Department of Energy

Subject: Lakeview, Oregon, Uranium Mill Tailings Radiation Control Act (UMTRCA) Title I
Disposal Site's West Side Slope Rock Degradation Assessment

Response to NRC's November 12, 2014, Letter Item 3:

LAKEVIEW TYPE B RIPRAP

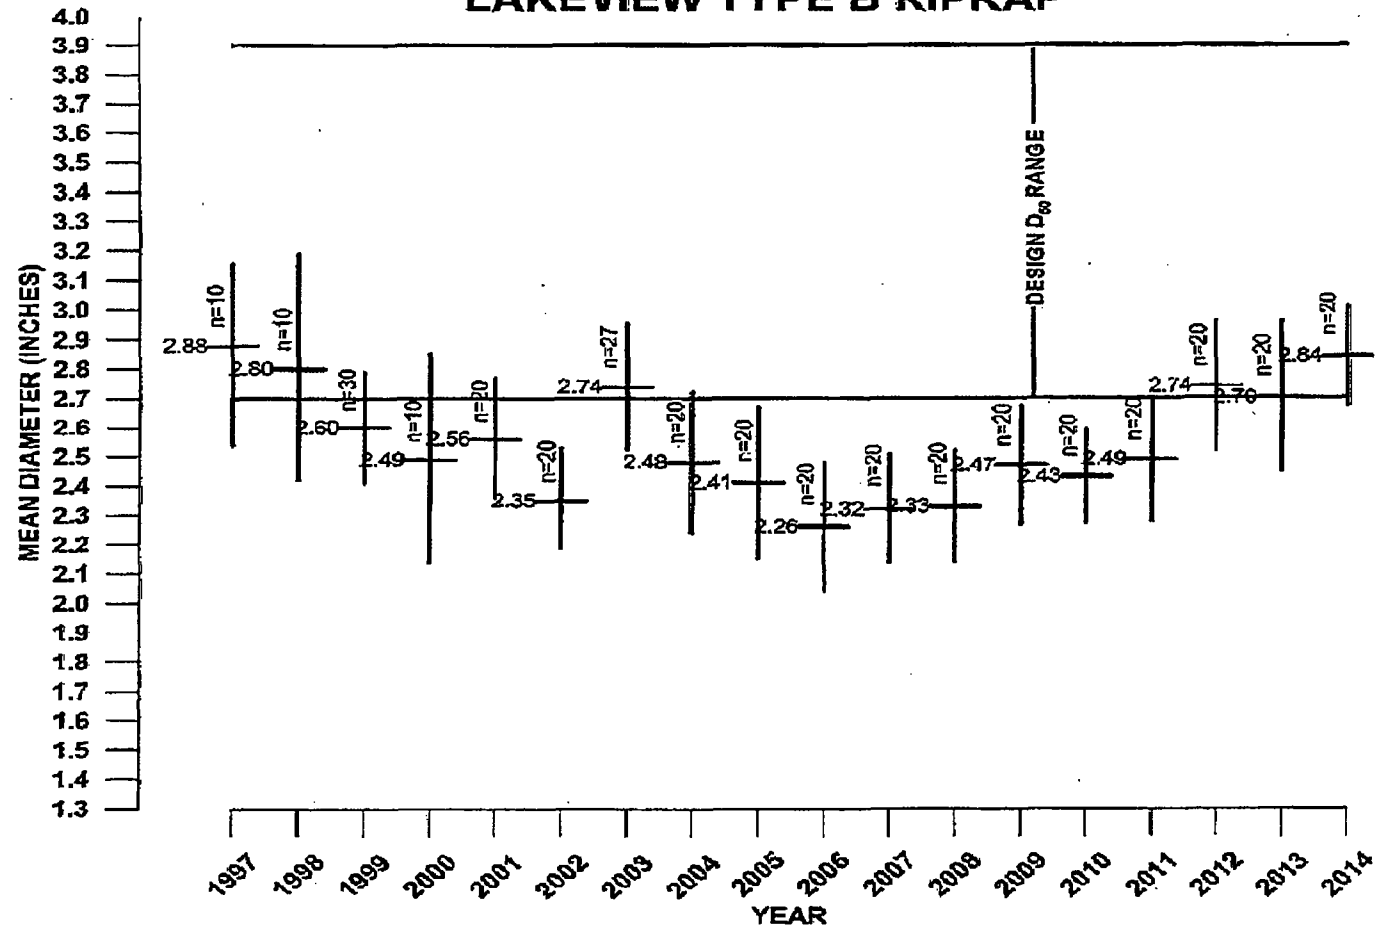
- Attachment 1 provides summary data results and information, including (1) a graph plotting values for the mean diameter (D_{50}) results of the annual gradation monitoring conducted over the past 18 years; (2) tables identifying the various rock types, with descriptions, and durability classes/codes of rock present on the side slope; (3) a table summarizing the 6 years of rock durability monitoring results by durability class; and (4) a map showing the local reference to which the monitoring sample location coordinates apply.

- The D_{50} measurements obtained since 1997 (see graph in Attachment 1) indicate that degradation of the Type B size riprap is inconsistent but that it has occurred.
- Gradation monitoring results shown on the graph in Attachment 1 for the years 1997 to 2014 indicate variability in the D_{50} measurement. Some of this variability is natural randomness, and some could result from different personnel performing the procedure. However, a rate of rock degradation cannot be determined.
- The annual gradation monitoring results shown on the graph in Attachment 1 indicate that the average D_{50} value for the 18-year monitoring period is 2.55 inches. Without the 1997 value, which was atypically performed by weight instead of rock count, the 17-year average D_{50} value is 2.53 inches. This is less than 0.2 inches below the calculated size range lower
